Response to Reviewer #1 comments

The paper of Pranic et al. entitled 'Performance of the Adriatic Sea and Coast (AdriSC) climate component – a COAWST V3.3-based coupled atmosphere-ocean modelling suite: ocean part', presents an evaluation of the ocean component of the AdriSC climate system against a huge data collection. This study complete a previous evaluation paper that was dedicated to the atmospheric component of the same numerical model run of a 31-year long period (1987-2017). The ocean evaluation is conducted for sea surface, thermohaline properties and circulation.

Figure R1: Time variations of the amplitude of EOF1 for both observation and model.

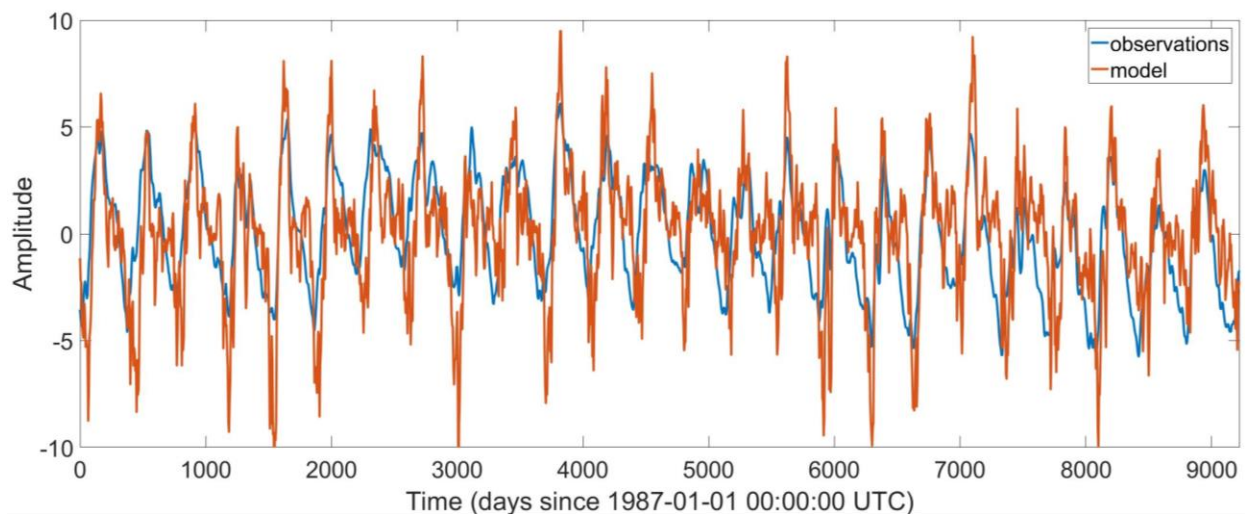
3. Section 3.1.1: Looks like there is a conspicuous difference in the EOF1 amplitude. Did the authors calculate correlation coefficients between the amplitude of observation and amplitude of the model?

Response: The correlation coefficient between observed and modelled EOF1 is 0.65 and the normalized standardized deviation is 1.19 which shows that the model amplifies the seasonal signal by comparison to the observations (see Fig. R1 above). The manuscript has been changed as follow:

“Overall, it can clearly be seen that, for both Adriatic and northern Ionian Seas (Fig. 2), the first EOF component (EOF1) represents the seasonal variability of both AdriSC ROMS 3-km and JPL_MEASURES results with spatial signal and amplitudes slightly stronger in the model (i.e. 81.2% of the total signal with amplitudes varying between ± 8.0 ; Fig. 3) than in the observations (i.e. 74.5% of the total signal with amplitudes ranging between ± 6.0 ; Fig. 3). Additionally, the correlation coefficient between the time variations of the observed and modelled EOF1 is only 0.65 associated with a normalized standard deviation of 1.19.”
